## PLANNING APPLICATIONS COMMITTEE

23/P2431

**Address/Site:** Outside 13 Station Buildings, Coombe Lane, Raynes Park

**Proposal:** FULL PLANNING CONSENT FOR THE PROPOSED INSTALLATION OF ADVERTISED COMMUNICATION HUB UNIT WITH DEFIBRILLATOR.

## SITE PLAN AND IMAGES

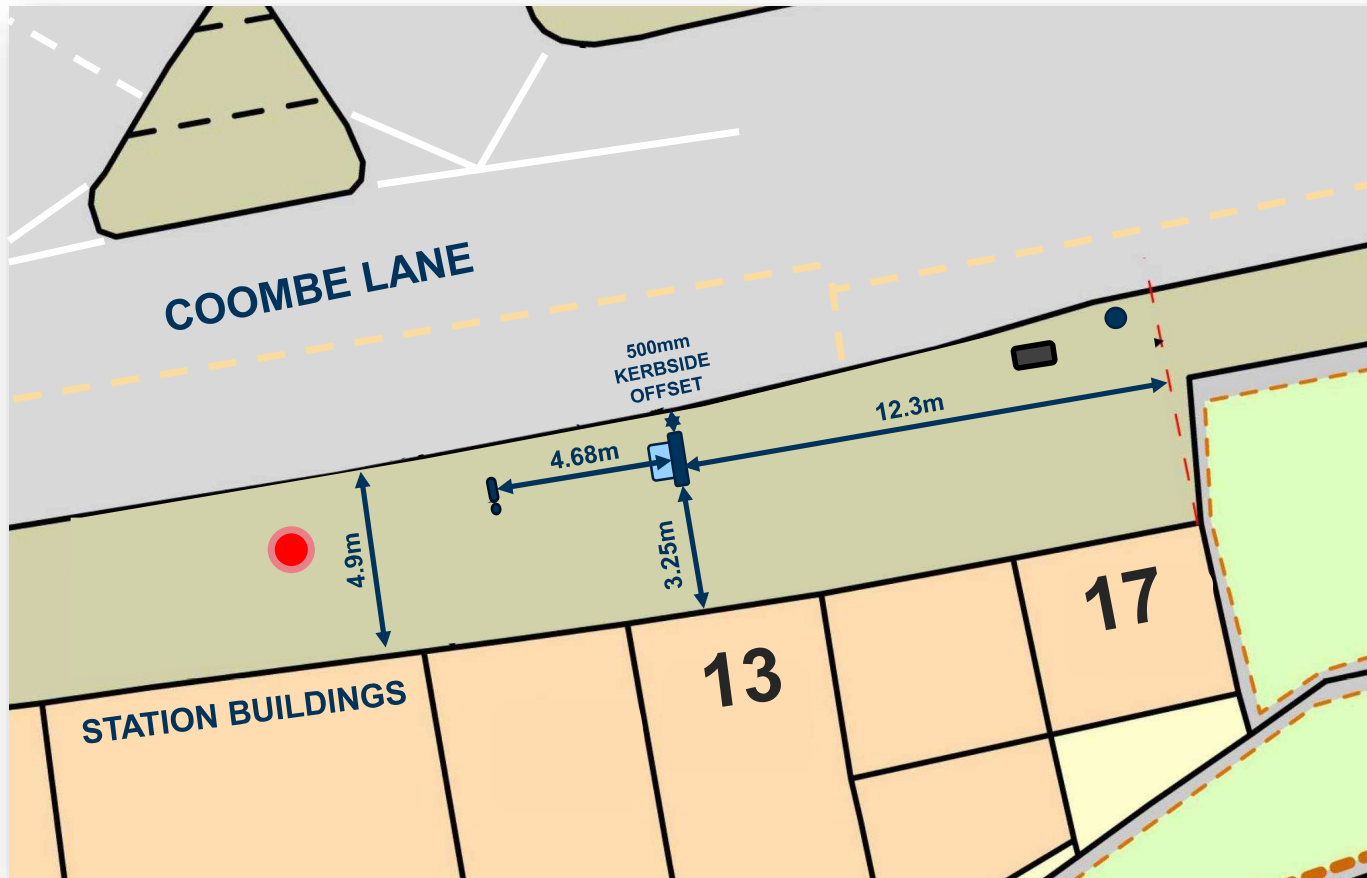
The communication unit is shown on the submitted drawing as being 800mm from the kerblines when it should be 450 from the kerblines to allow sufficient space for pedestrian movement.

Revised comments following receipt of amended plans:

Proposal now acceptable.

- 7.24 The proposed unit has been moved closer to the pavement edge upon request from the Highways Officer which results in the unit being less of an obstruction to users of the pavement. It is therefore considered the advertisement panel would not have an undue detrimental impact on the character and appearance of the pavement or wider street scene and is compliant with Policies DM D5 and DM D2.
